Attachment 1 Response-to-Comments Table

Application for Amendment of Plan Under Section 12A of the Town Planning Ordinance (Cap.131), to Rezone the Application Site from "Open Storage", "Agriculture" Zones and an area shown as 'Road' to "Other Specified Uses" annotated "Mixed Use" Zone, for Proposed Mixed Use Development at Lots 796 and 1008 RP in D.D. 77 and Adjoining Government Land in Ping Che, Ta Kwu Ling, New Territories Response to Departmental Comment

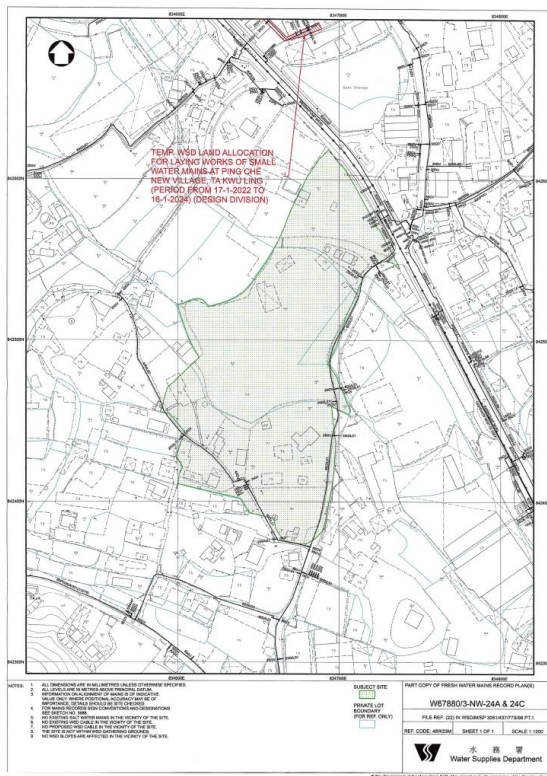
<p>If diversion is not required, the following conditions shall apply:</p>	
<p>(a) Existing water mains are affected as indicated on the site plan and no. development which requires resiting of water mains will be allowed.</p>	<p>Noted.</p>
<p>(b) Details of site formation works shall be submitted to the Director of Water Supplies for approval prior to commencement of works.</p>	<p>Noted.</p>
<p>(c) No structures shall be built or materials stored within 1.5 metres from the centre line(s) of water main(s) shown on the plan. Free access shall be made available at all times for staff of the Director of Water Supplies or their contractor to carry out construction, inspection, operation, maintenance and repair works.</p>	<p>Noted.</p>

- (d) No trees or shrubs with penetrating roots may be planted within the Water Works Reserve or in the vicinity of the water main(s) shown on the plan. No change of existing site condition may be undertaken within the aforesaid area without the prior agreement of the Director of Water Supplies. Rigid root barriers may be required if the clear distance between the proposed tree and the pipe is 2.5m or less, and the barrier must extend below the invert level of the pipe. Noted.

- (e) No planting or obstruction of any kind except turfing shall be permitted within the space of 1.5 metres around the cover of any valve or within a distance of 1 metre from any hydrant outlet. Noted.
